**RE: Completeness Responses  
Vigo Coal Operating Co., LLC.  
Friendsville Mine  
Permit 330 & 458 – SIG. REV.**

Please accept the following material for completeness responses for Vigo Coal's 330 & 458 Permit – SIG. REVISION as outlined below.

Completeness Revisions - Sig. Revision to add a fine course refuse impoundment and to add developed water to the reclamation plan.

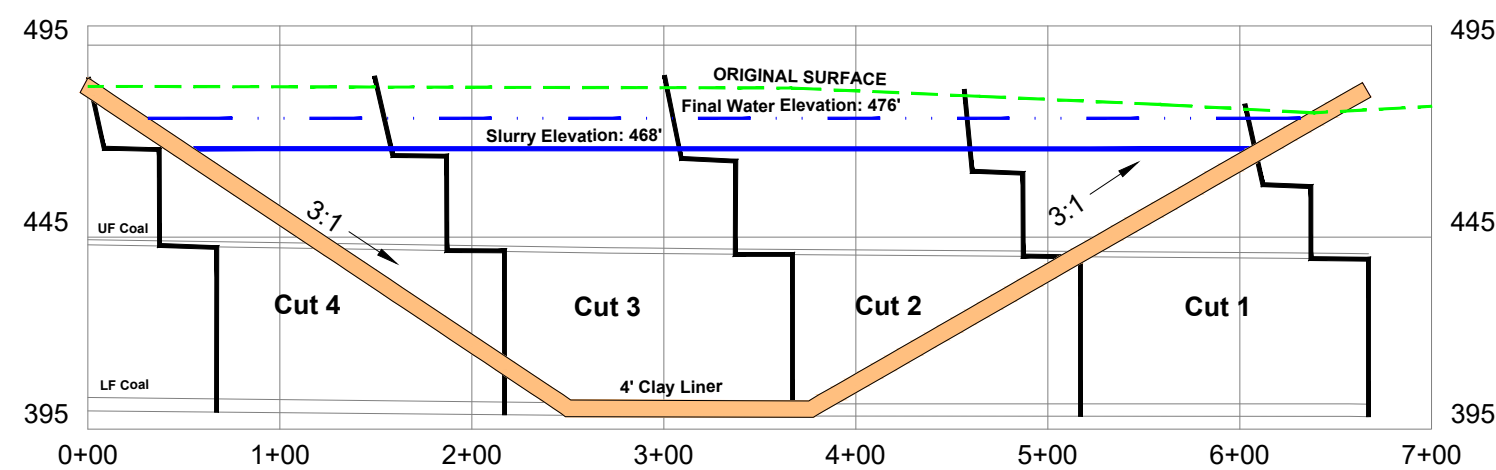
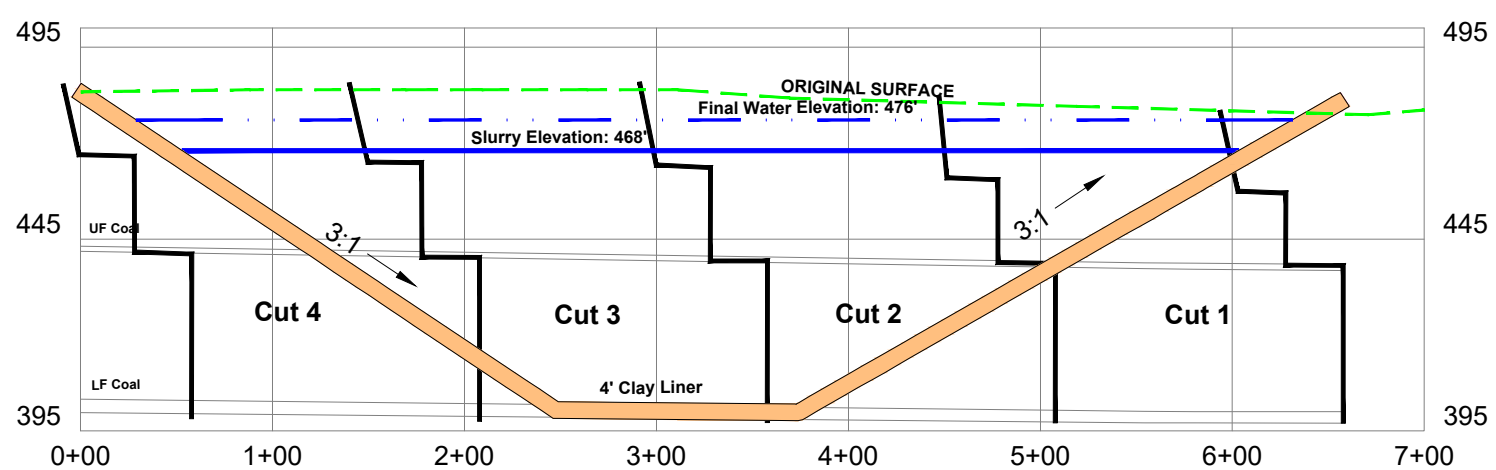
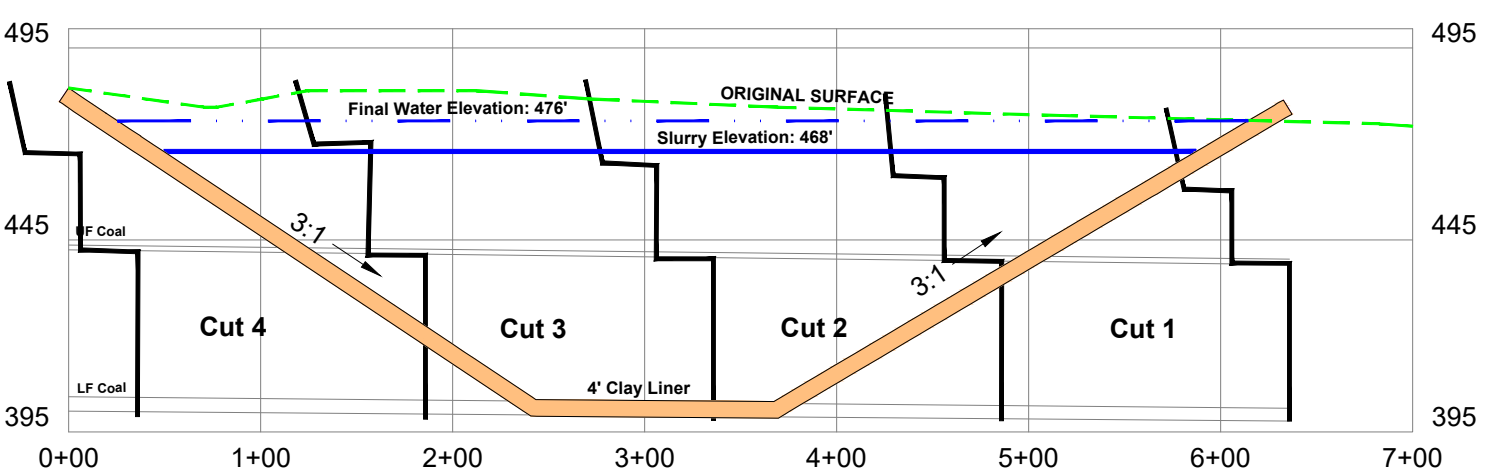
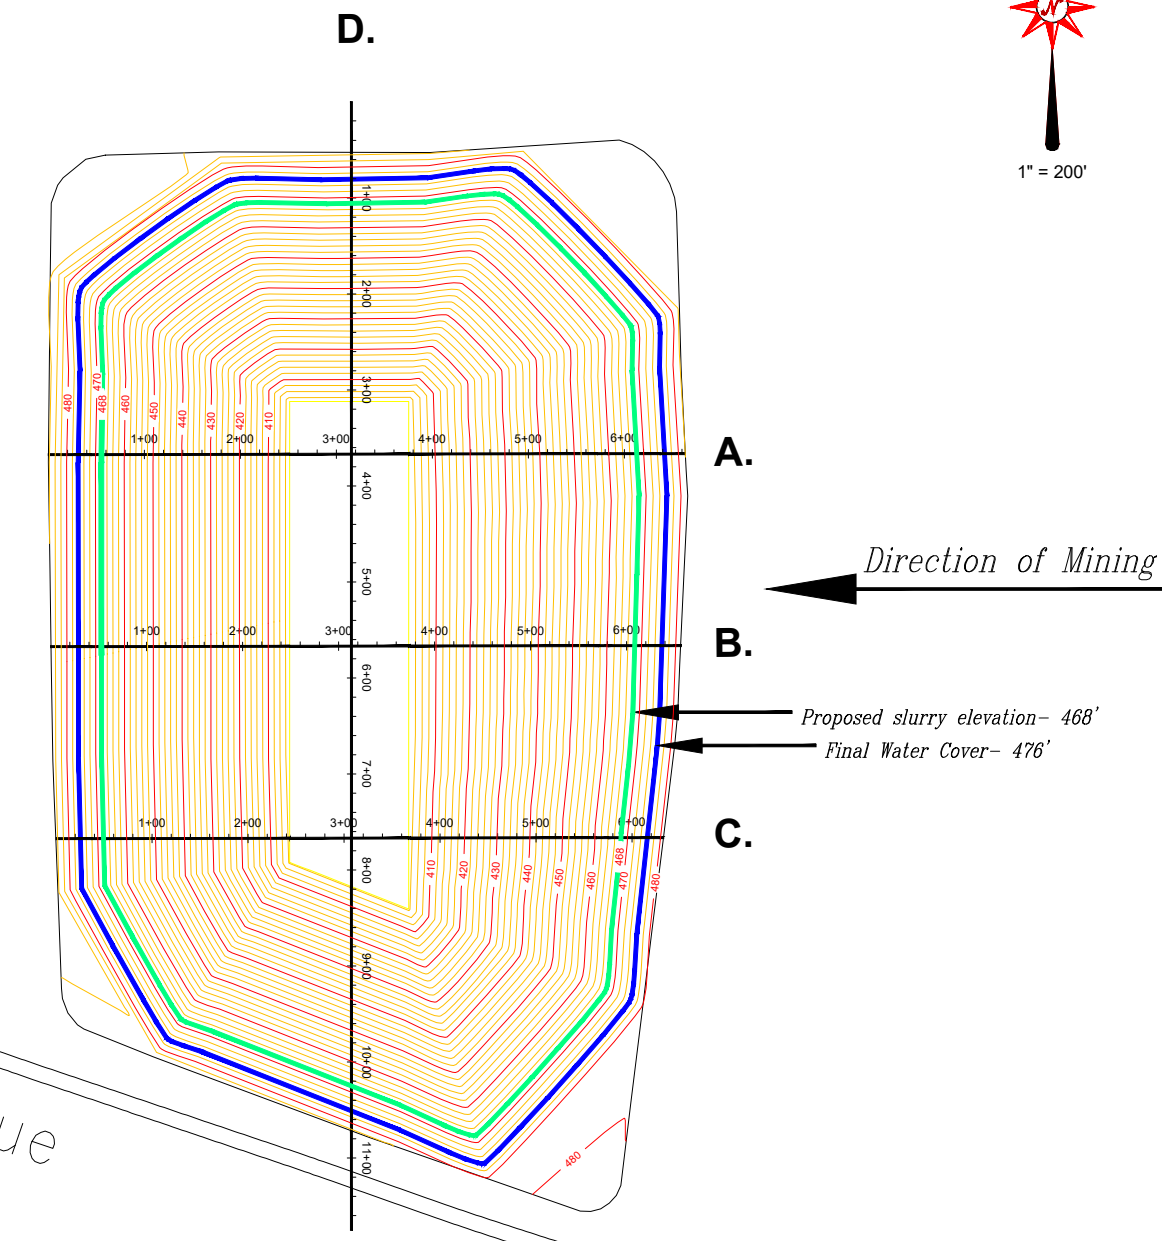
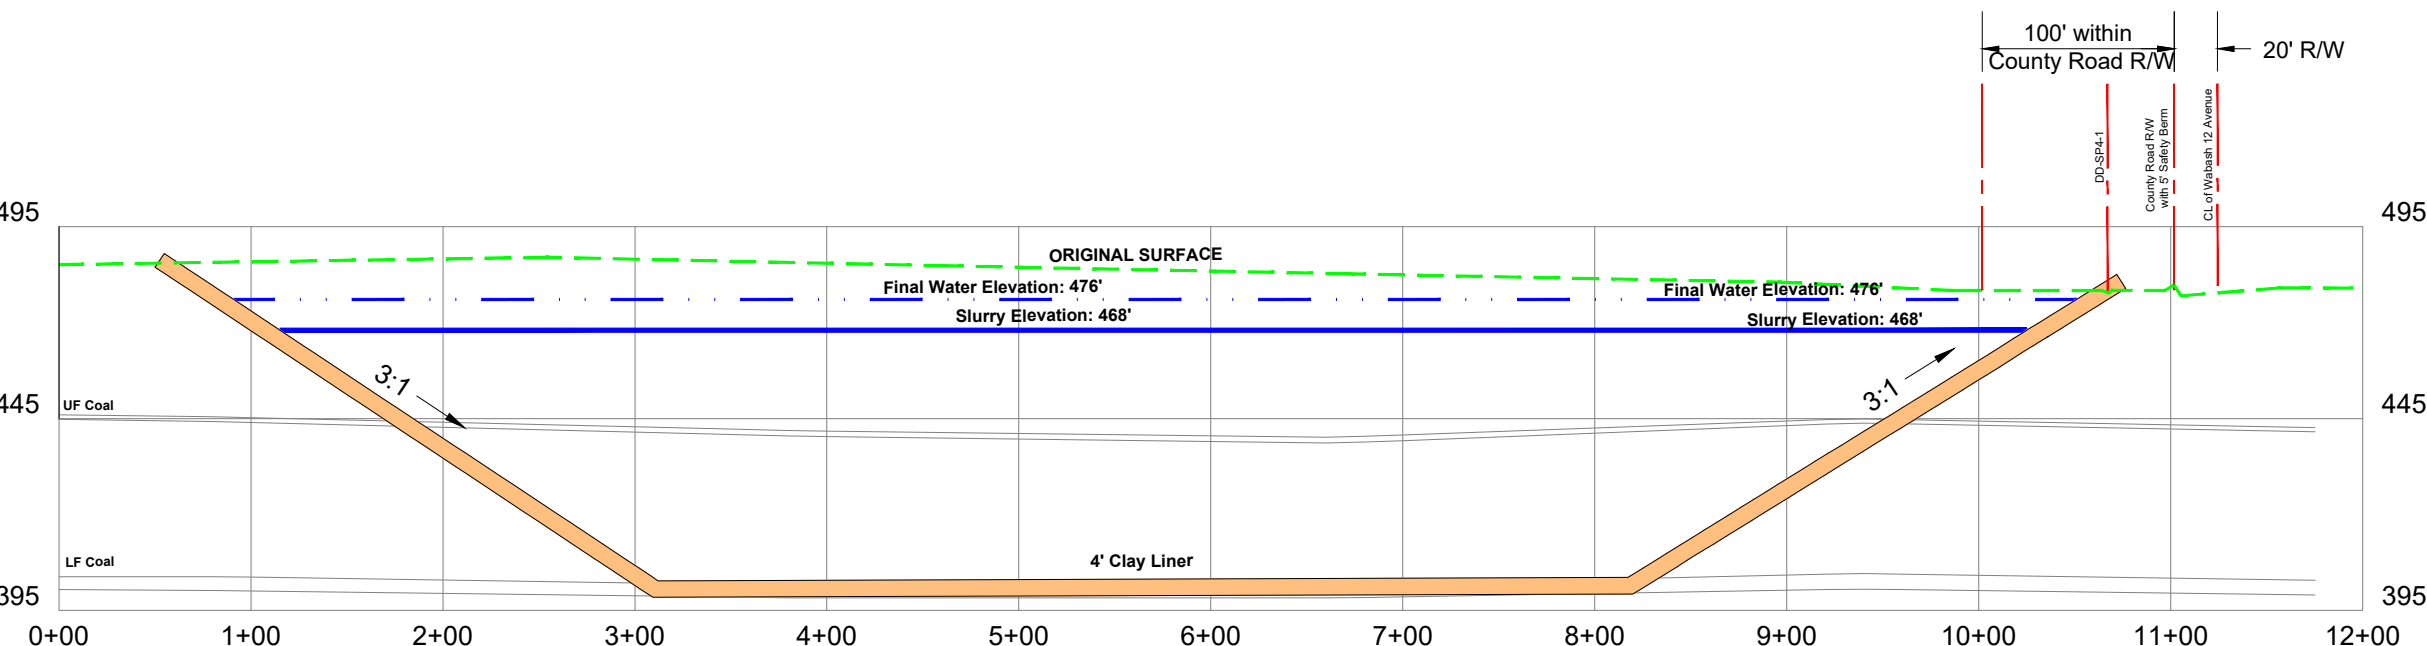
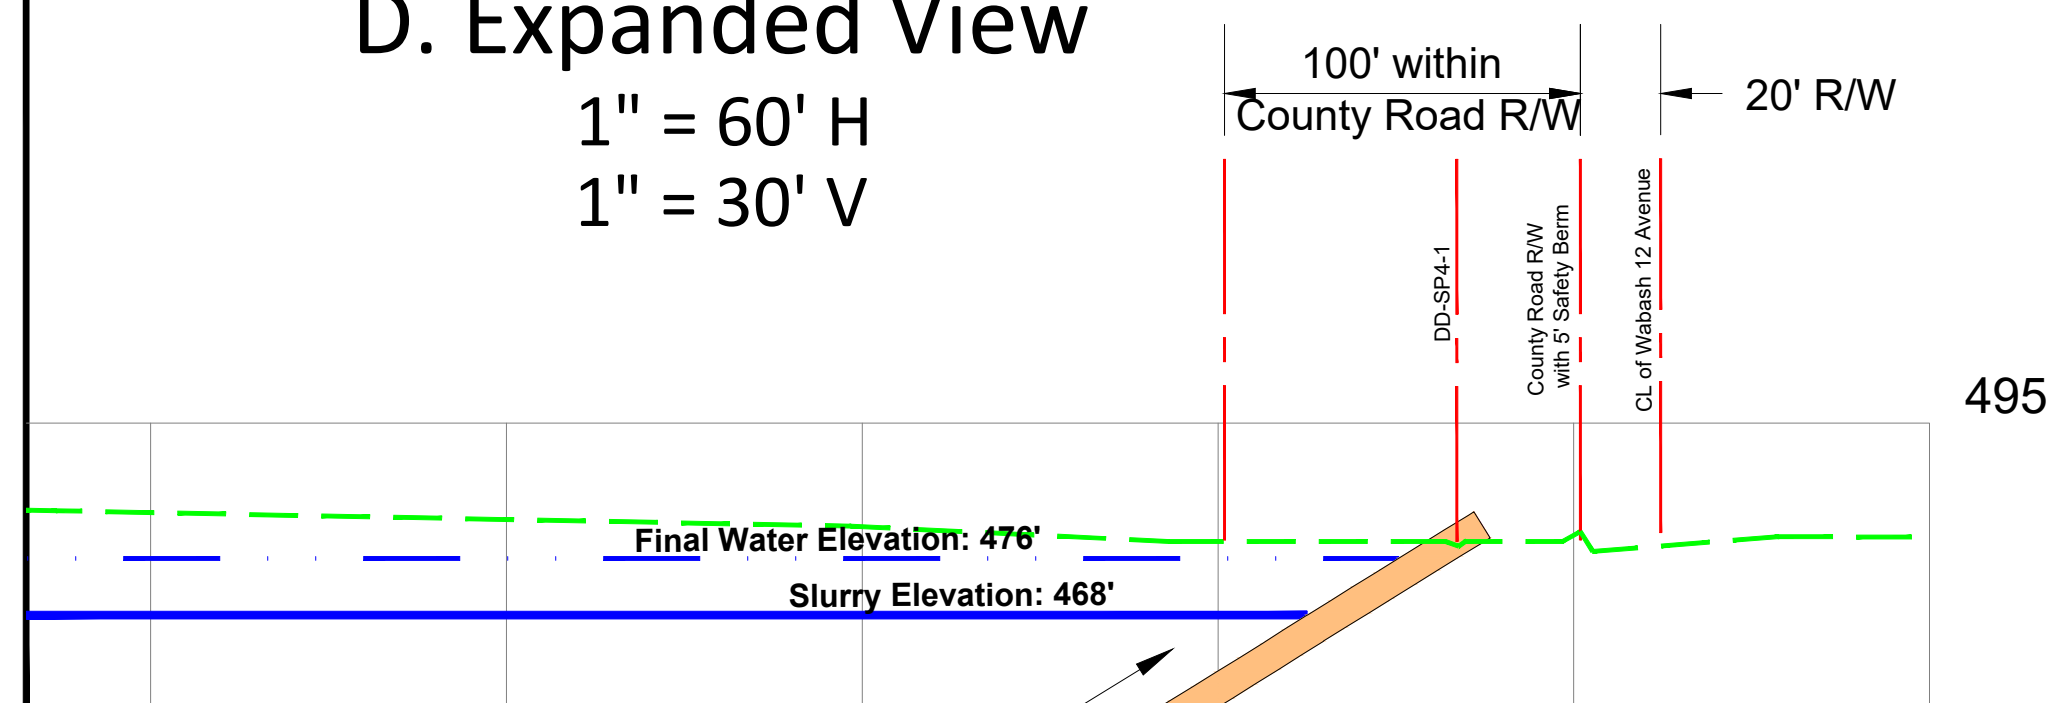
1. The applicant has included the location of Wabash Avenue Centerline, and Wabash Avenue ROW, however the safety berm and the diversion ditch cross section is not included on Attachment 3.12.2.1. To ensure compliance with 62 Ill. Adm. Code 1780.14(b), the applicant shall include a detailed cross section of the area of interest within cross section D, in which the south edge of the Slurry Pond #4, the diversion ditch and the safety berm are within Wabash Avenue ROW and come in proximity to the road. **An expanded view of Section D. has been provided in Attachment 3.12.2.1. The expanded view shows all activities within 100 feet of the county road right of way.**

**Slurry Impoundment 4**

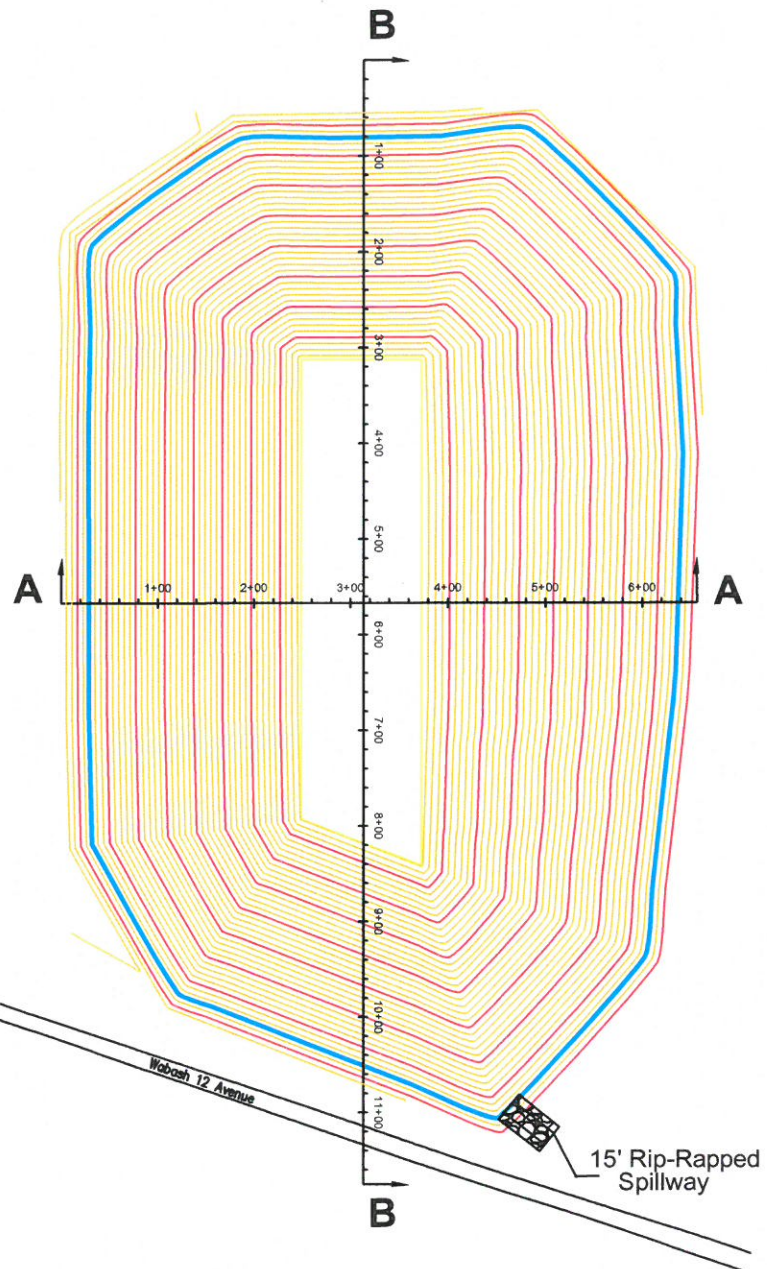
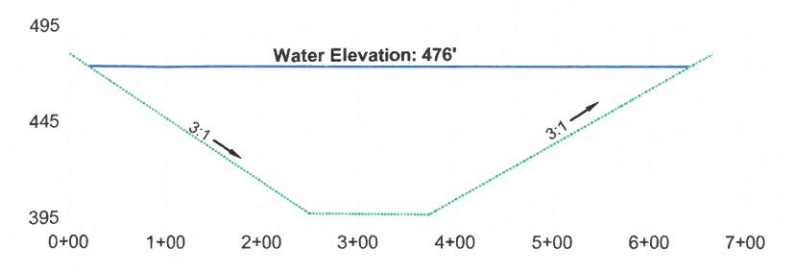
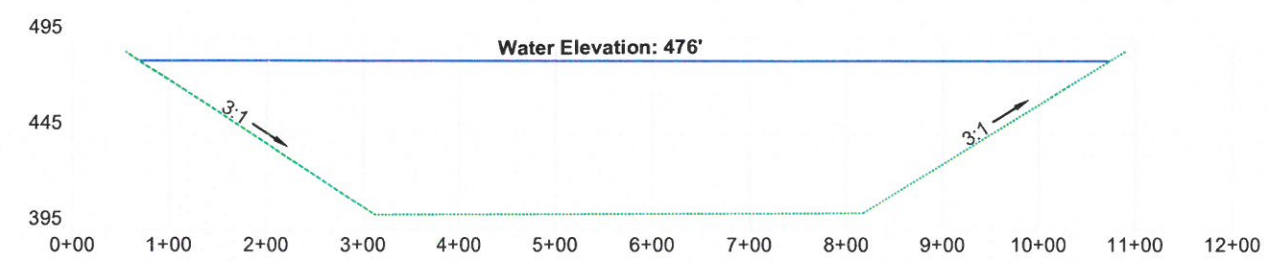
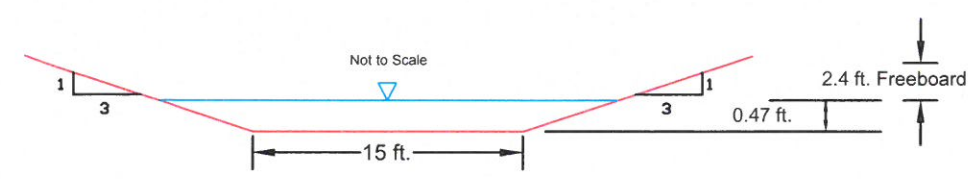
3. The applicant provided Attachment 9.4.1 but, the applicant did not include the question of this part of the application. Pursuant 62 Ill. Adm. Code 1780.25(a) and (c), the applicant shall include the question 9.4 and its respective answer. Specifically, details that have not been included in the application and shall be addressed are: water level of the final pool elevation of Slurry Pond #4, relationship of the refuse disposal area to the post-mining land use, sampling plan of refuse material for neutralization material rates and description of final drainage configuration of the impoundment. **Part 9.4 was added to the application. Final pool elevation was added to**

**Attachment 3.12.2.1 and is also shown on Attachment 5.4.1.2. Attachment 9.4.1 was revised to address neutralization rates. None are proposed, water cover will be sufficient to prevent oxidation. The final configuration for the impoundment can be found on Attachments 3.12.2.1 and 5.4.1.2**
